Jerrold Vitek

9146 Aerie Lake Road Aerie Lake

Request

Applicant Site SketchProposed Dwelling

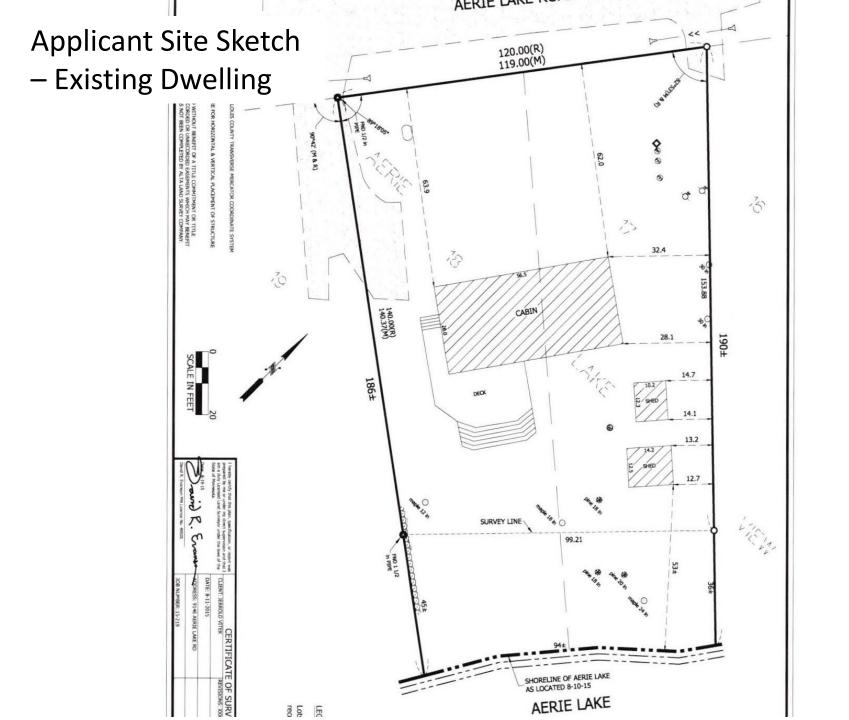
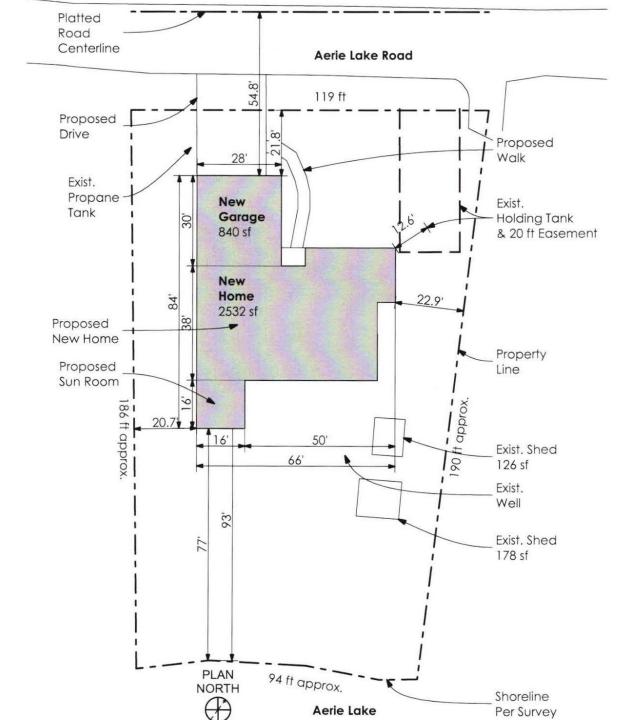
- The applicant is proposing to replace a 56 foot by 28 foot dwelling located 88 feet from the shoreline (field measured) where 100 feet is required.
 - The proposed replacement dwelling is 66 foot by 84 foot and proposed to be located at 72 feet from the shore.
- The replacement dwelling is proposed to be 66 feet in width, 61 percent of the lot width.
 - The existing dwelling is currently 56 feet wide and 51 percent of the lot width.
- Then nonconforming parcel is comprised of two platted lots of 0.44 acres (19,167 square feet).
 - The applicant is proposing a structure of 3,372 square feet, 18 percent of the lot area.
 - Including two existing sheds, the total proposed building footprint would be 3,676 square feet and 19 percent of the lot area.

- 1. Zoning Ordinance 62, Article III, Section 3.4, states that the required shoreline setback on a Recreational Development lake is 100 feet.
 - a. The existing structure is nonconforming at 88 feet from the shore (field measured) and the applicant is proposing to reduce the setback to 72 feet from the shore.

- a. The current dwelling is 56 feet wide and 51 percent of the lot width. The proposed dwelling is 66 feet wide and 61 percent of the lot width.
- 3. Zoning Ordinance 62, Article IV, Section 4.4 A., states that lots that do not conform to the minimum area standard are allowed a maximum building footprint of 15 percent of lot area.

- a. At 0.44 acres (19,167 square feet), the lot does not meet the one acre requirement of Zone District 7.
 - b. The applicant is proposing a structure of 3,372 square feet, 18 percent of the lot area. Including the existing two sheds, building footprint is proposed to be 19 percent.
